SERVICE INSTRUCTION

Introduction of new spark plug, spark plug connector and cylinder head for ROTAX® Engine Type 582 UL Mod. 17

ATA System: 74-00-00 Ignition system

Fig. 1
Spark plug

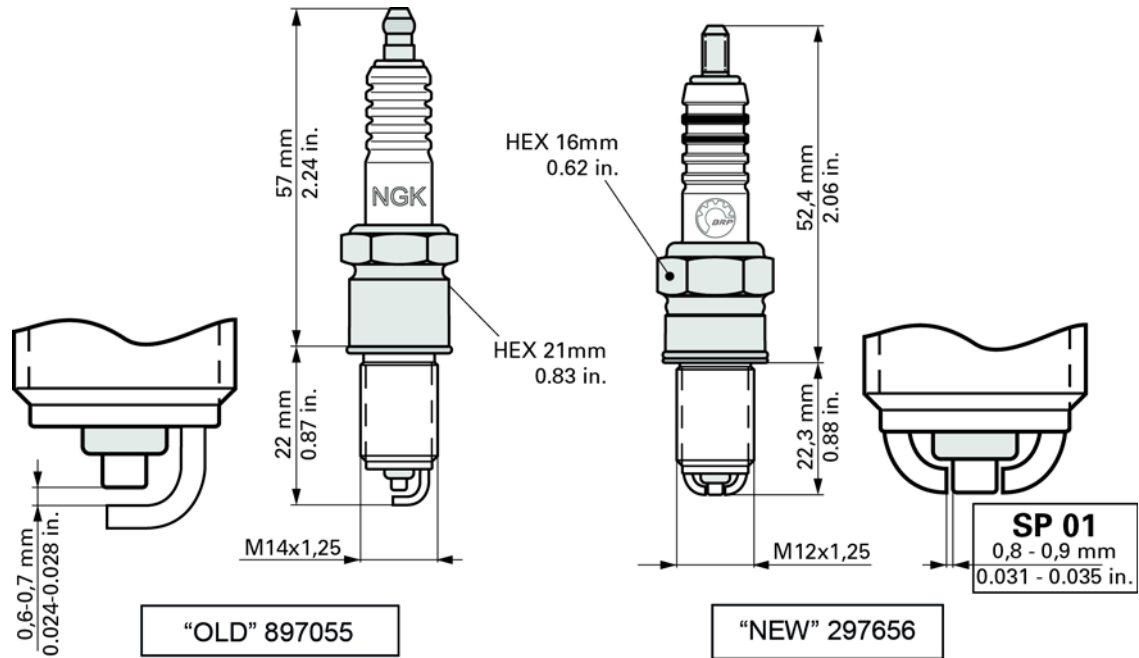
NOTICE To avoid spark plug damage, make sure to use a correct "spark plug" wrench/socket. While the old spark plugs had a size of A/F 21 / hex. 21 mm (0.83 in.), the new ones do have hex. 16 mm (0.62 in.). See Fig. 1.

Fig. 2
Spark plug connector

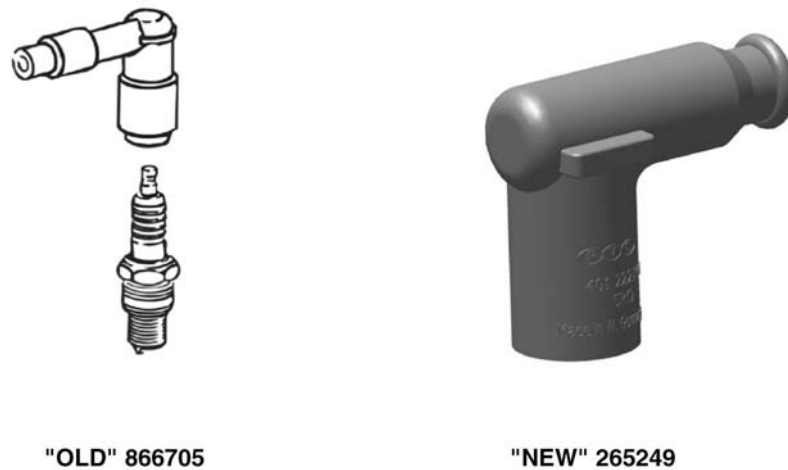
The new spark plug connectors are of different design and will not fit on the old spark plugs. Mixing of old and new spark plug connector types is not allowed. All spark plug connectors must be of the same part number for the entire engine.

Additional to the change of new spark plugs, the spark plug connector type was also changed. See Fig. 2 for more details.

Fig. 3
Special tooling

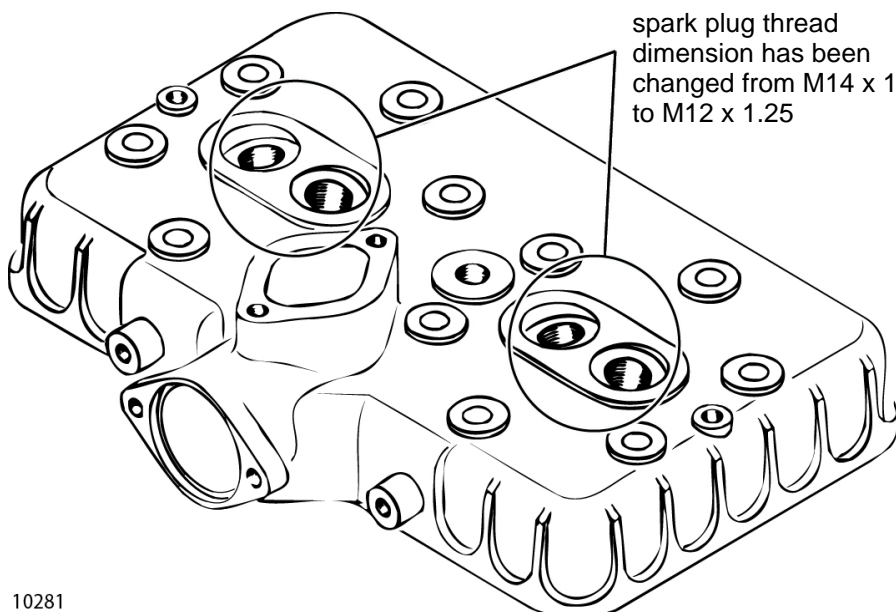
For easier removal of the spark plug connector from the spark plug and to avoid spark plug damage from side load, use proper spark plug socket pliers. See Fig. 3.

Fig. 5
New gauge adapter

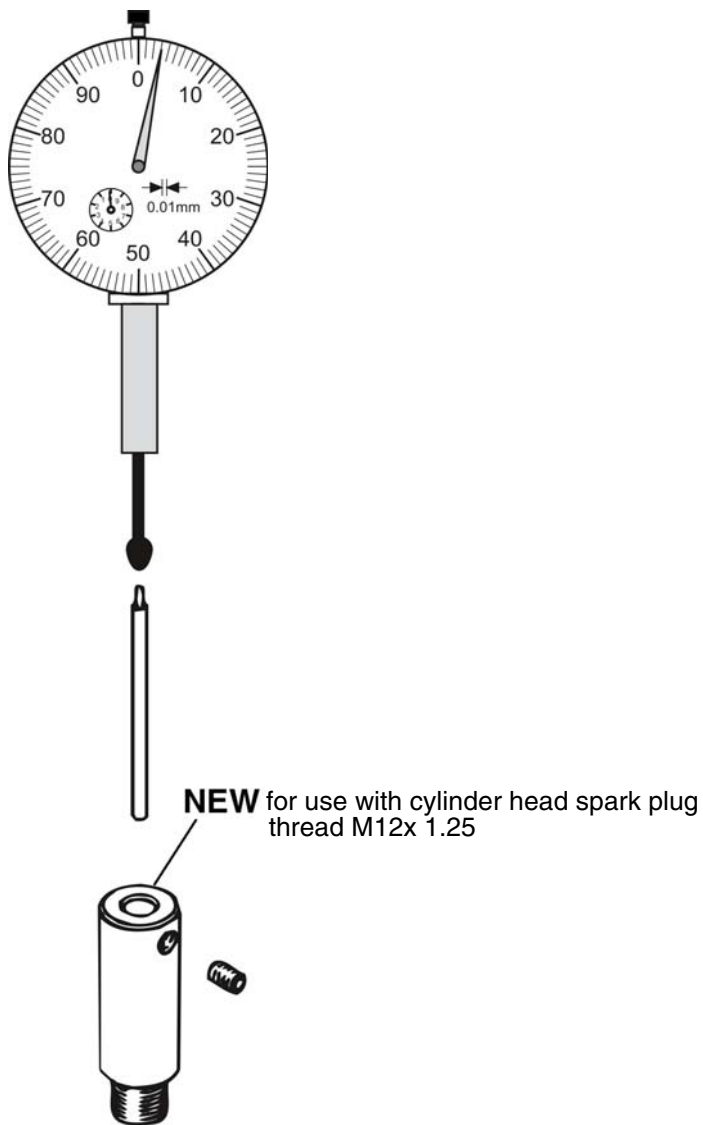
Also make sure to consider the different thread size of the spark plug bore, when using a dial gauge threaded into the spark plug bore e.g. for:

The relevant gauge adapter is also available under the new part no. 876942 considering this design change (see Fig. 5).
